**PIC10F220/222 Rev. A Silicon Errata**

The PIC10F220/222 parts you have received conform functionally to the Device Data Sheet (DS41270B), except for the anomalies described below.

**FIGURE 1: TYPICAL DNL AT 2.0V (TESTING AT 7-BIT LEVEL)**

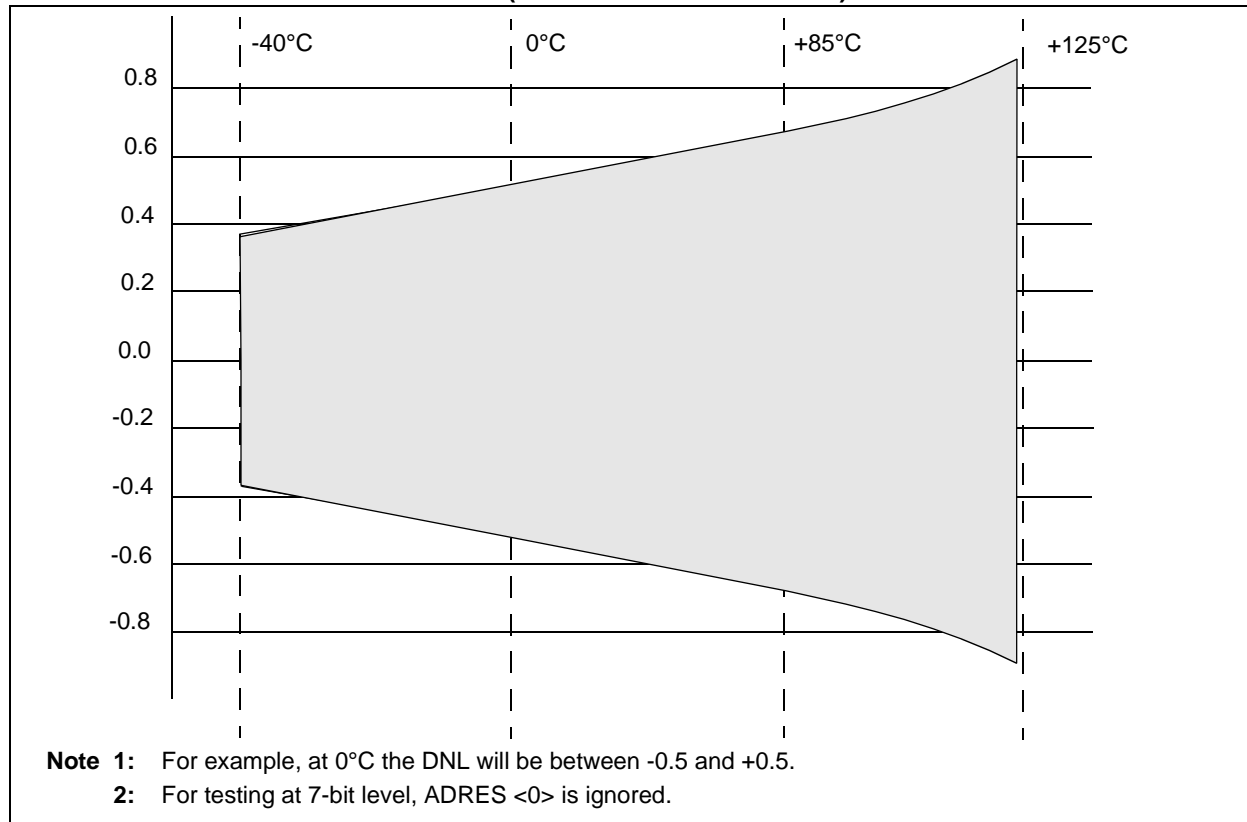
PIC10F220/222 silicon Rev. A1. The A/D Converter does not meet the design target. The specifications listed below in Table 10-6 supersede Table 10-6 in DS41270B.

None.
